**SUSQUEHANNA STEAM ELECTRIC STATION
PROPOSED AMENDMENT NO. 282 TO
FACILITY OPERATING LICENSE NPF-14:
PROPOSED CHANGE TO TECHNICAL SPECIFICATION 2.1.1.2
MCPR SAFETY LIMIT
PLA-5967**

PPL SUSQUEHANNA EVALUATION OF PROPOSED CHANGE TO UNIT 1 TECHNICAL SPECIFICATION 2.1.1.2

**Proposed Technical Specification Change
(Markups)**

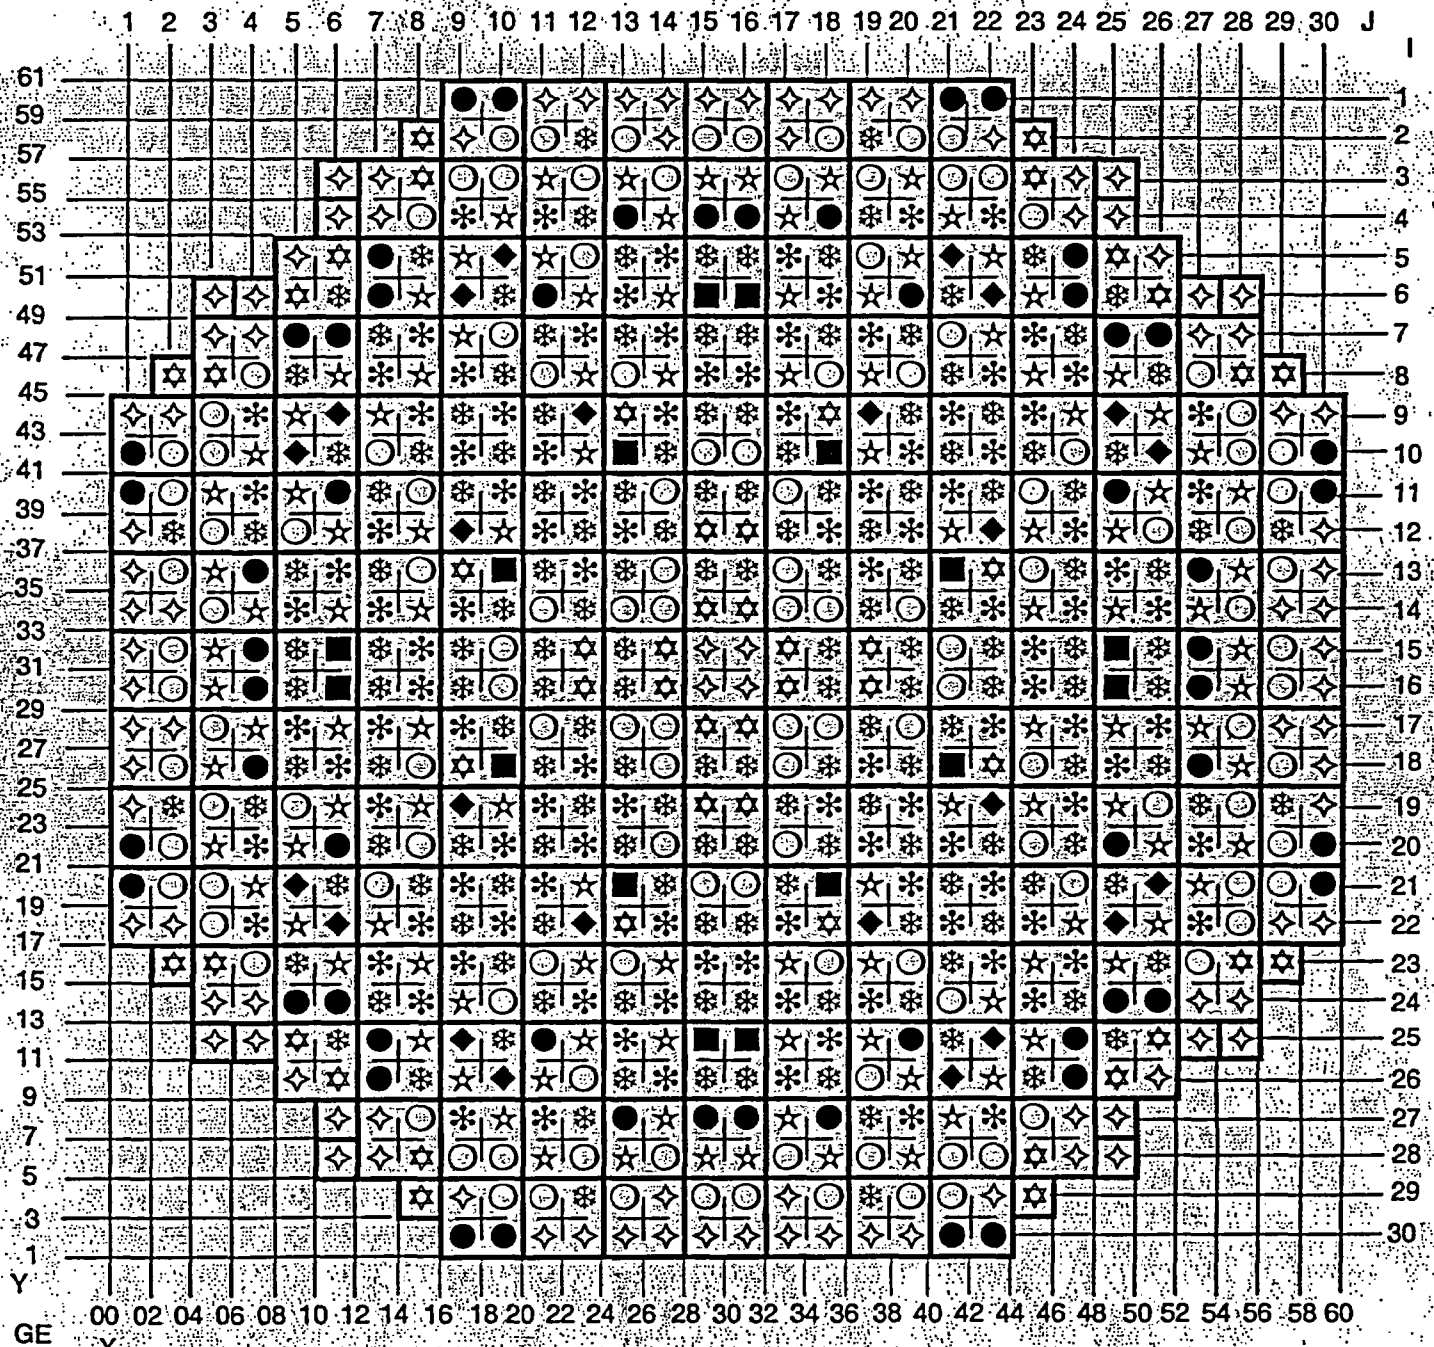
M CPR shall be \geq 1.09 for two recirculation loop operation or \geq 1.10 for single recirculation loop operation.

The proposed change would revise Unit 1 TS Section 2.1.1.2 with regard to the Minimum Critical Power Ratio (MCPR) Safety Limit for two-loop operation from 1.08 to 1.09. This value reflects the results of the Unit 1 mid-cycle 14 core redesign and cycle specific MCPR Safety Limit analysis.
